J14 1048

APPROVED  
FEB 25 1985  
HYDROLOGY SECTION

**DRAINAGE / GRADING PLAN**  
**SPECIAL SYSTEMS INC. WAREHOUSE**  
**1301 EDITH BLVD. N.E.**

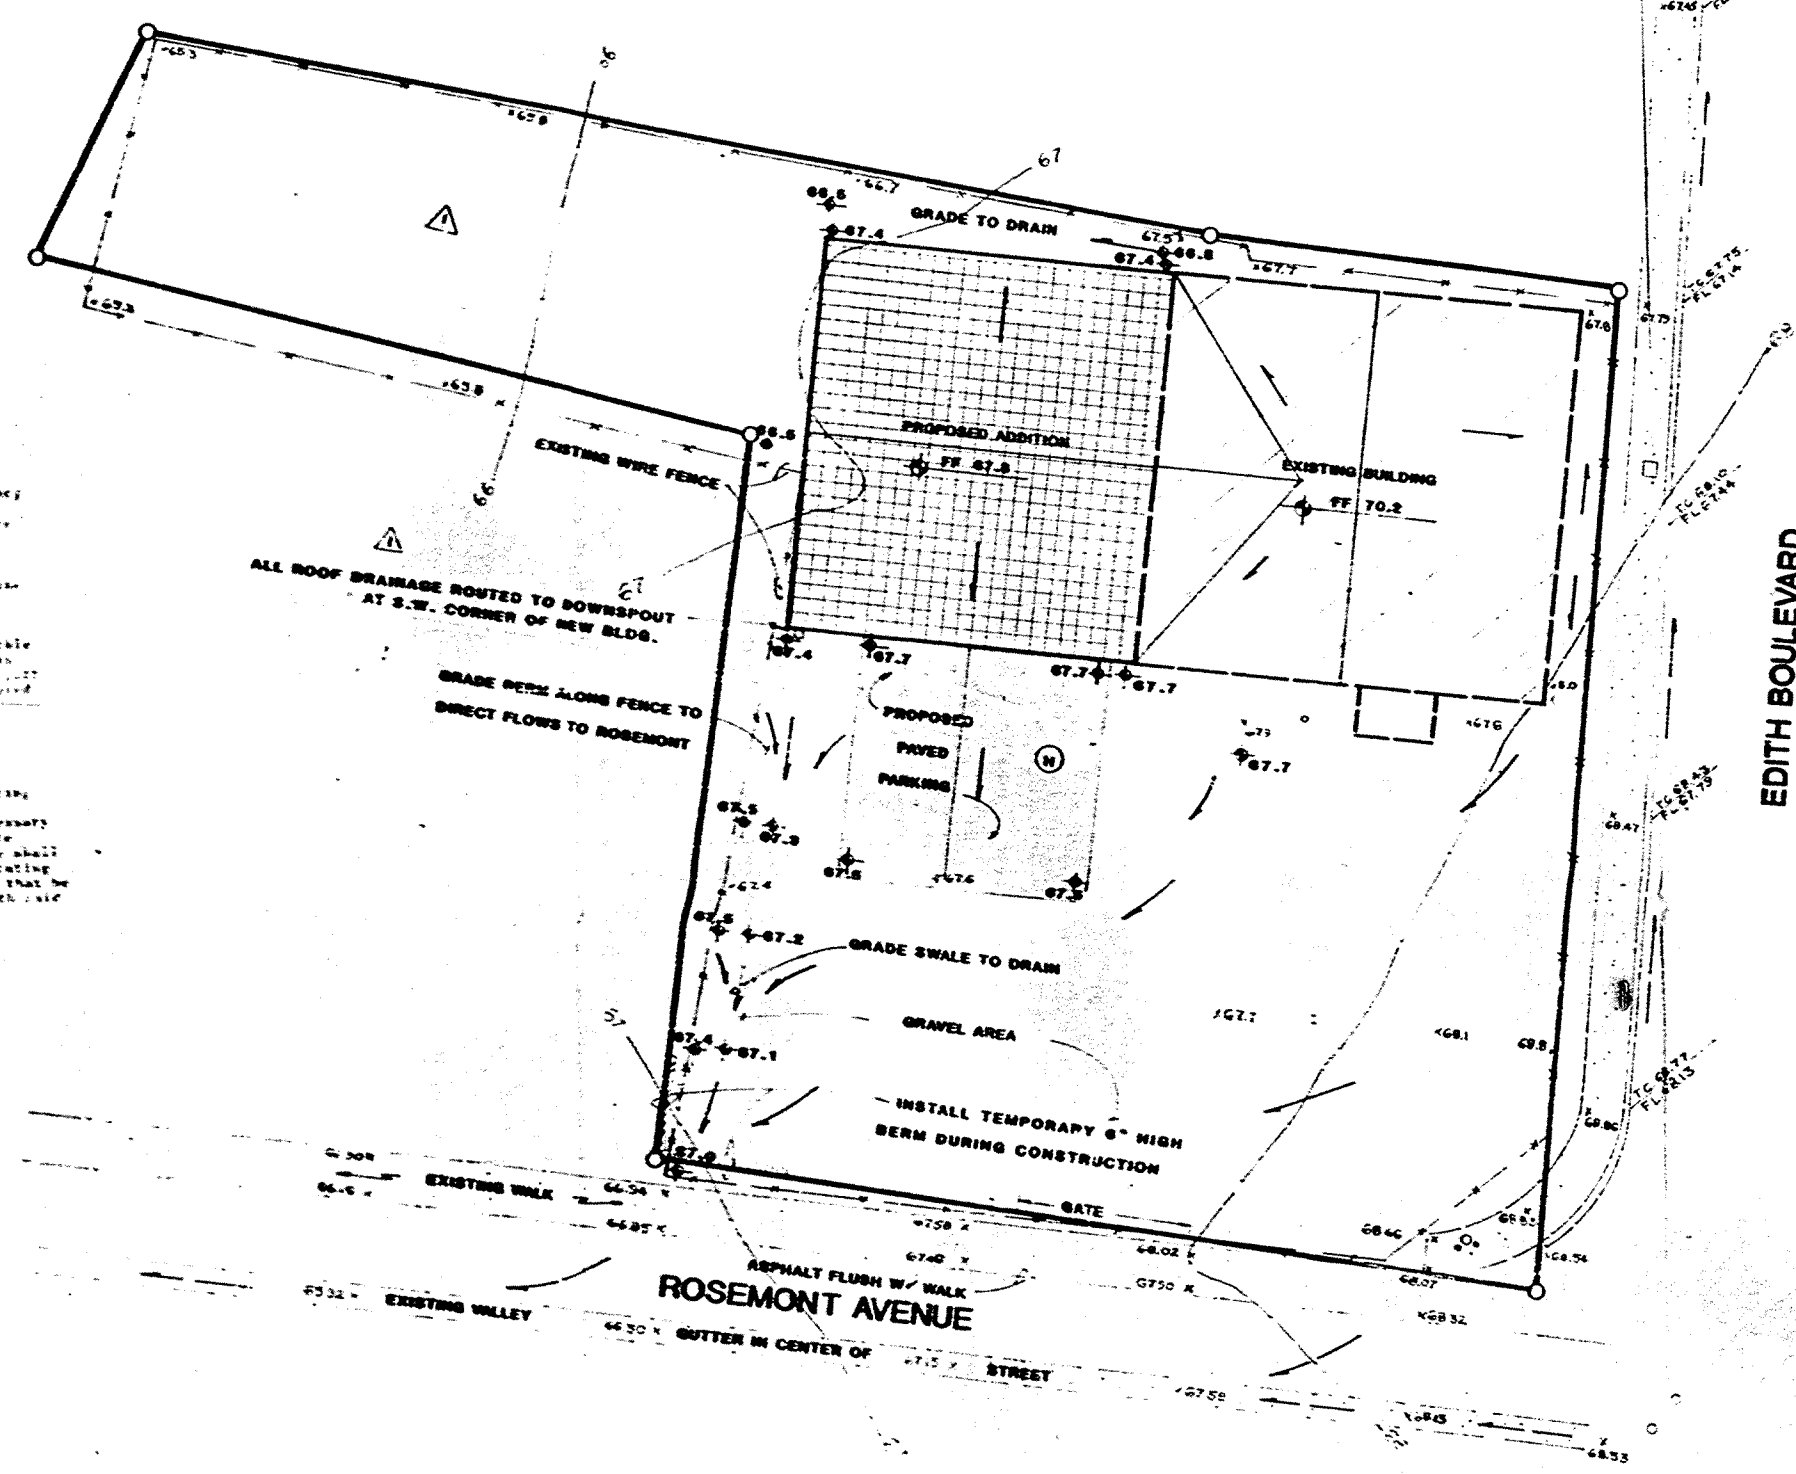
RESUBMITTED 2-25-85  
POND REMOVED FROM N.W. CORNER &  
WATER ROUTED TO DOWNSPOUT AT  
S.W. CORNER OF PROPOSED ADDITION  
W.B. Nunn  
WALT HINES  
2-25-85  
DATE
